**RE: DEVELOPMENT APPLICATION SUB2023/001
PROPOSED 284 LOT RESIDENTIAL SUBDIVISION
RESPONSE TO ADDITIONAL INFORMATION REQUIRED – STORMWATER ITEMS.
52-54 MILES STREET, YAMBA NSW 2464**

ADDITIONAL INFORMATION REQUEST RESPONSE - STORMWATER

DEVELOPMENT APPLICATION SUB2023/0001 52-54 MILES STREET, YAMBA NSW 2464

Figure 6.7 TUFLOW Pre-Development Model Extent

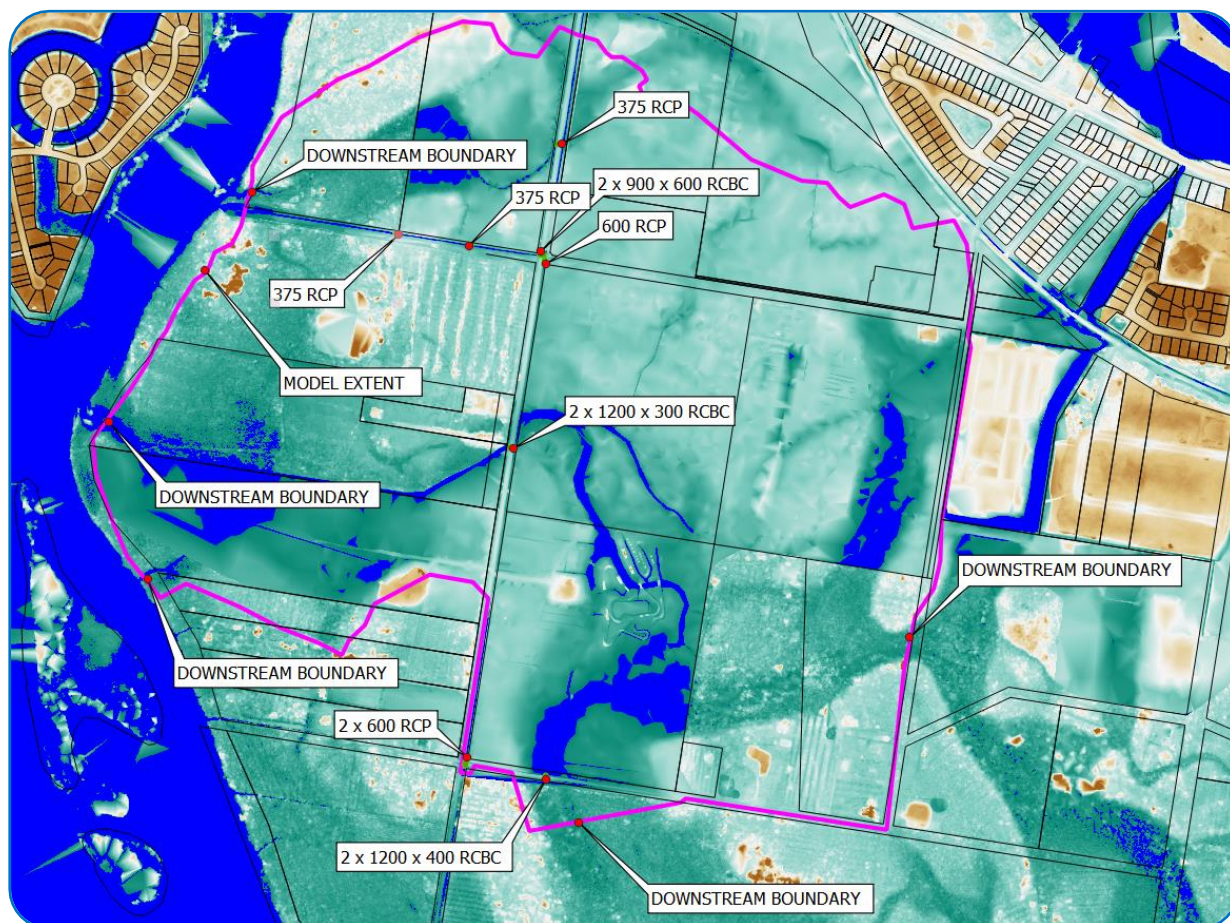
6. The model boundary located along Golding Lane and Sullivans road are at a close proximity to the culverts along these roads. The model boundary should be extended to properly model the flow behaviour through culverts. This will most likely not change the modelling outcomes but ideally it would minimise the impact of outlet.

The model boundary has been extended a further 50 m downstream. The model has been rerun and no material changes have occurred to the results. Refer to Figure 6.7 of the attached SMP&DAv4.

Figure 6.7 within Section 6.3.3 of the revised report (V4) has been amended to include the modelled drainage structures.

Figure 6.13 TUFLOW Post-Development Model Extent

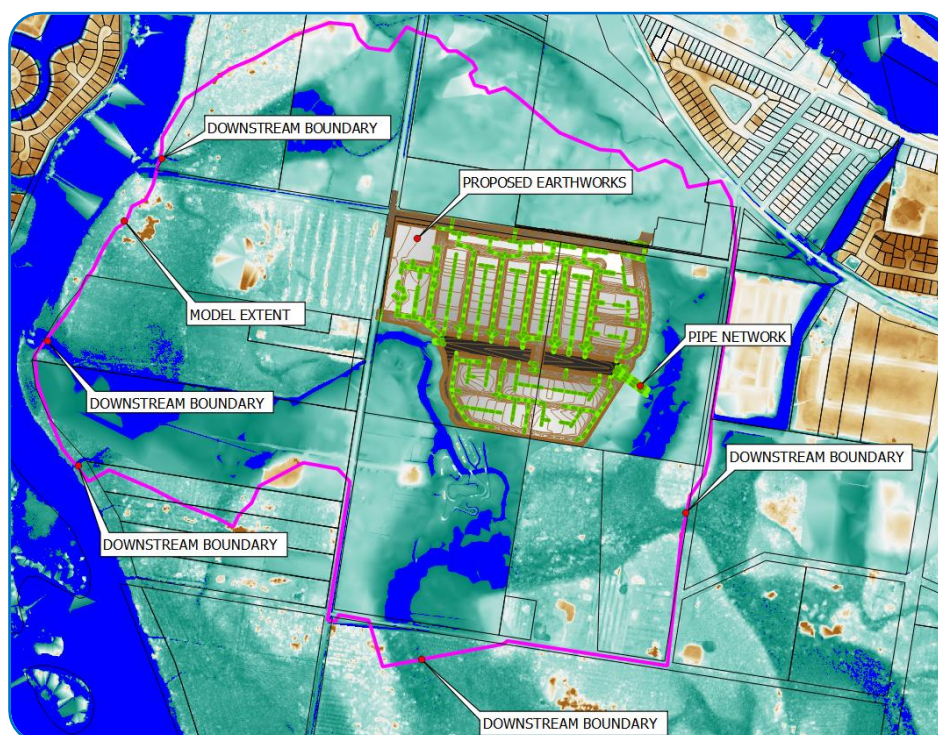
- 15. The green line is not described in the legend. Perhaps reducing width of the green lines could better show the velocity impact along the roads.

A legend has been added to Figure 6.13 (refer to attached report) to identify the green lines as "stormwater pipe network". The post development result plots (Figures 6.14 to 6.16) have been amended to remove the pipe network so as to more clearly indicate flooding depth and velocity.

Figure 6.20 1% AEP Flow Direction Plot Pre-Development

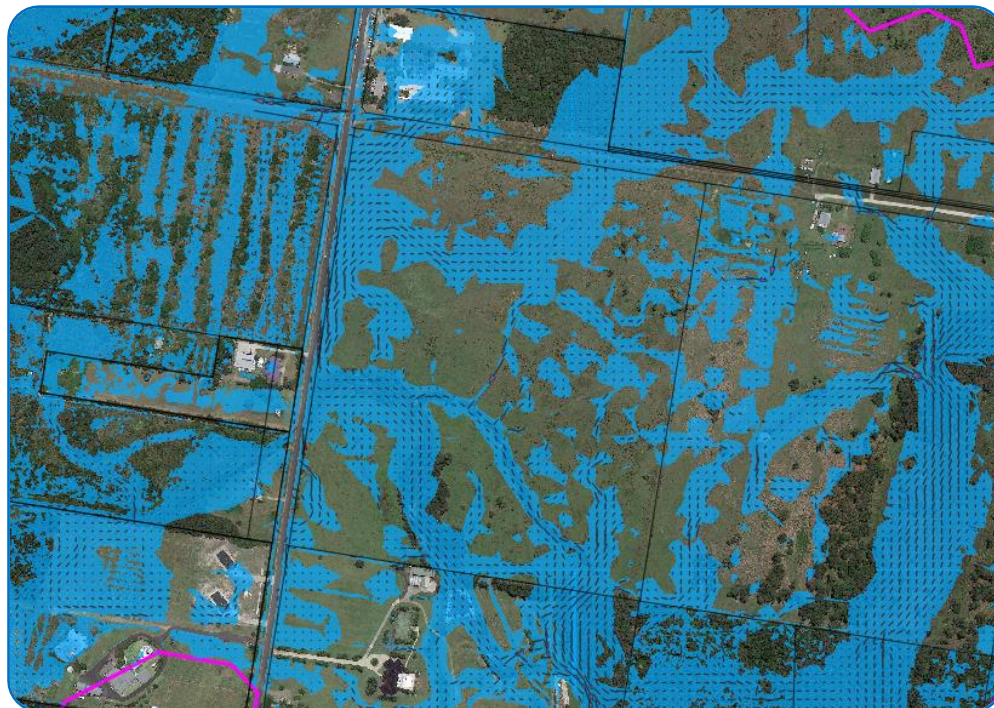
14. Section 1.1 states an objective to maintain a Lawful Point of Discharge (LPD) for all site catchments in accordance with QUDM (2016). Please provide commentary on this based on the TUFLOW model results. It would be useful to add flow directions figures.

Each point of discharge has been assessed against the above criteria and it is considered that a Lawful Point of Discharge will be achieved at each discharge location. Provided that the design measures set out in this report are implemented it is not anticipated that substantial damage will be caused to a third party property at any discharge point. Figures 6.20 and 6.21 demonstrate the direction of the pre and post development local 1% AEP flows.
